KIRKLAND RAIDON
1310 NE 126TH PLACE
KIRKLAND, WA

DEVELOPMENT PLAN

DEVELOPMENT STANDARDS LIST

File: ZON16-02288

C-11

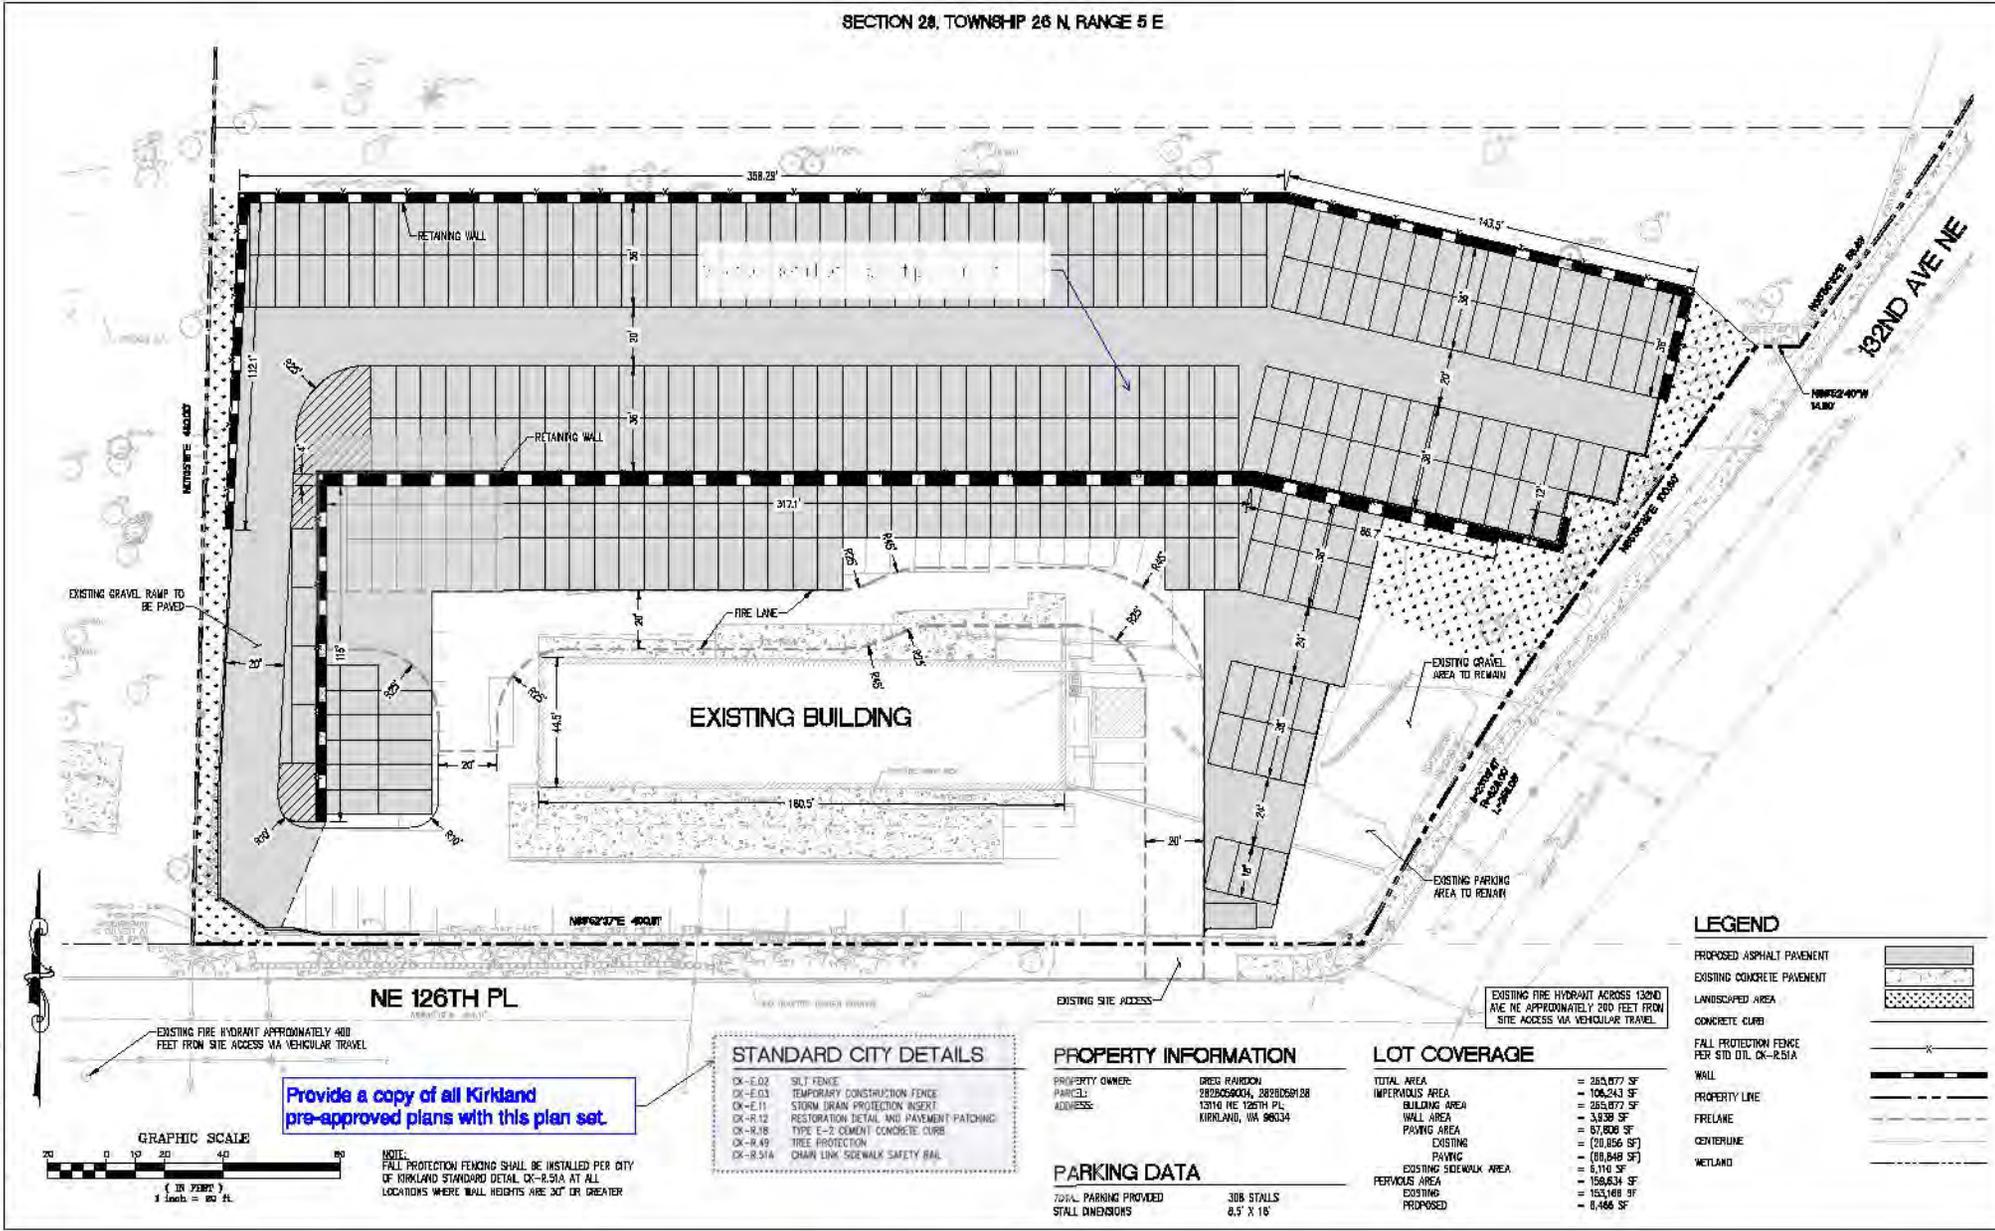
Provide a copy of all Kirkland pre-approved plans with this plan set.

Note: the civil plans show 2 detention vaults; although they are under the parking area, neither is under the driving area around the building. In the event that the location changes to be under the driving area, the vault shall be designed for fire truck loading.
